APPENDIX I

COMMENT LETTERS ON THE
DRAFT EIS AND RESPONSES

RE: Draft South Gillette Area EIS Comments

Figure 1. Time series plot of total dissolved solids at 180 C at alluvial aquifer monitor well CCA-14C, Coal Creek Mine, middle Powder River Basin, Wyoming, 2008.

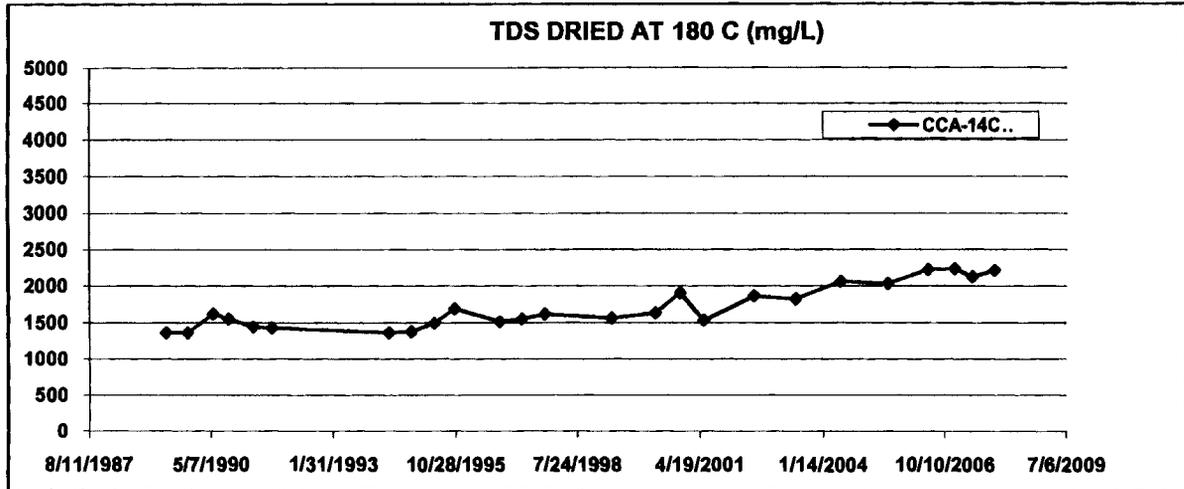
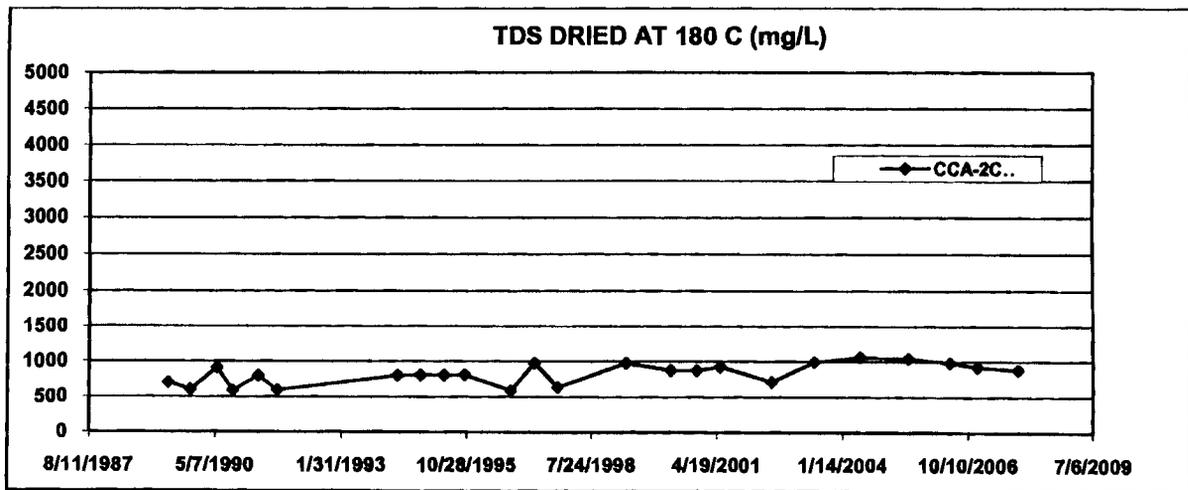
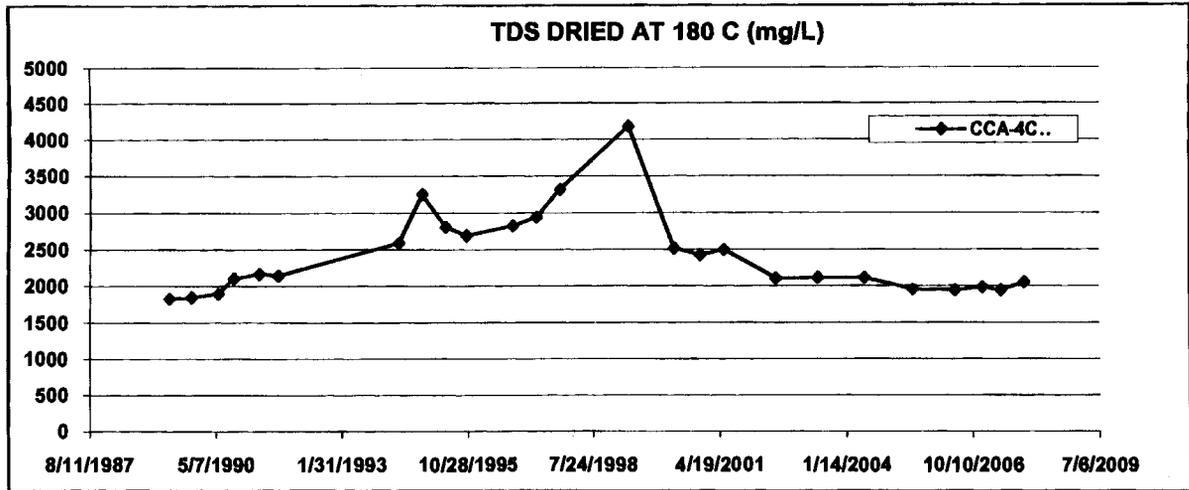
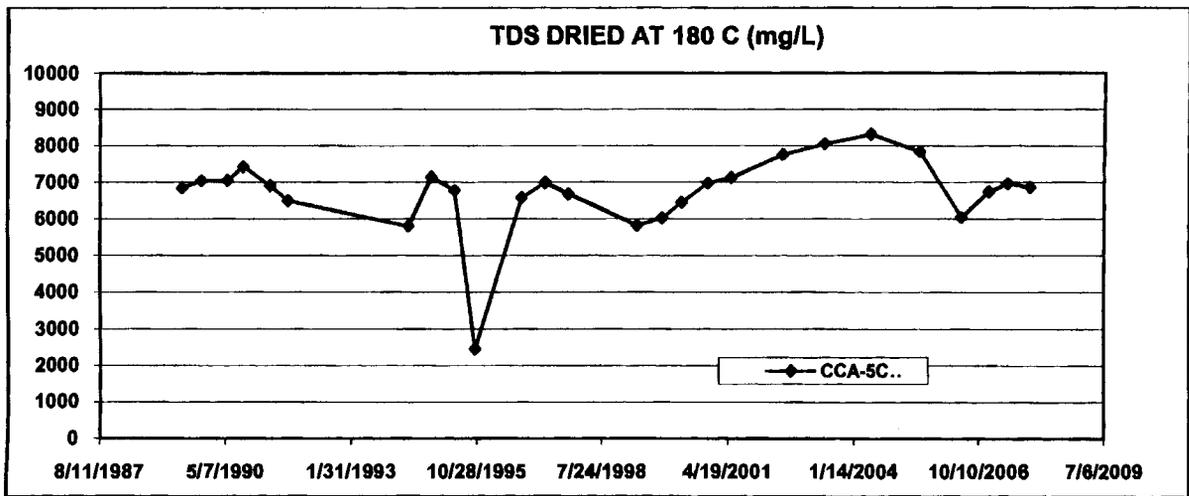
Data from these four wells indicate that only one, CCA-5A, exceeds the livestock standard for TDS for the latest's concentration and the maximum concentration. Time series plots are shown for TDS concentrations at each of the wells in Figures 1, 2, 3, and 4. Please note the concentration scale for Figure 4 is twice the concentration scale for the other figures. Based on TDS alone, well CCA-2C

is suitable for agricultural use and CCA-14C and CCA-4C have been or are approaching the agricultural use standard. Of course, there may be other constituents that impact the alluvial aquifer's use. If that is the case, those constituents and the supportive information should be included in the EIS.
